An
Coimisiún
Pleanála

FSC Report

ACP-323346-25

**Appeal v Condition
(Condition 13)**

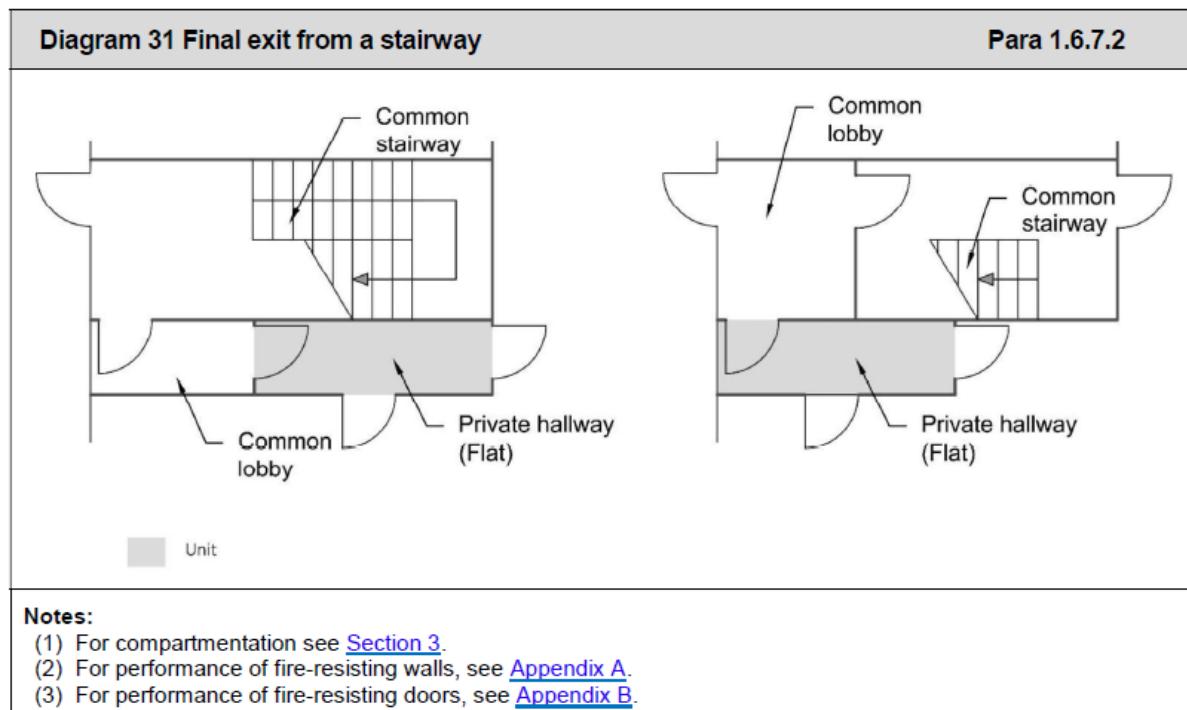
In carrying out this assessment one additional point arises. 1.3.7 of TGD-B requires that basement stairs be separated from a single stairs serving upper storeys by a protected lobby. There is an attempt to provide a protected lobby (annotated as ‘Entrance Hallway’) at ground floor level for this purpose however, in my opinion, the

layout proposed does not comply with 1.3.7 in that the sole means of escape from the single stairs is via the protected lobby (effectively rendering the lobby as being part of the stairs enclosure, not a separate lobby). There is a new Diagram 31 in TGD-B 2024 (copy below) which, although related to guidance on the separation of flats, illustrates the issue of common lobby versus common stairway.

The layout proposed in this case is as per the right hand side of Diagram 31, however no direct exit doorway from the stairs is proposed. In my opinion this proposed layout does not comply with Regulation B1. Given the Appellants desire to remove the condition requiring sprinklers in the basement car park this issue will need to be rectified.

In my opinion it is not possible to provide a protected lobby, as described in 1.3.7 of TGD-B, at ground floor level without significant design changes. There is already a protected lobby between the basement stairs and the basement car park, however I see no reason why a second (consecutive) protected lobby cannot be provided in this location effectively providing the double lobby protection resulting from compliance with 1.3.7 of TGD-B. The outermost lobby should be provided with a $0.4m^2$ permanent vent as per 1.3.8.4 of TGD-B (or mechanical equivalent as now permitted by TGD-B 2024).

The protected stairs linking the basement car park to the ground floor level shall be separated from the basement car park by double (i.e. two consecutive) protected lobbies of minimum 30 minute fire resisting construction, and FD30S rated self-closing fire doorsets, at basement level. The protected lobby immediately opening off the basement car park shall be provided with a permanent vent of 0.4m², or a mechanical equivalent.
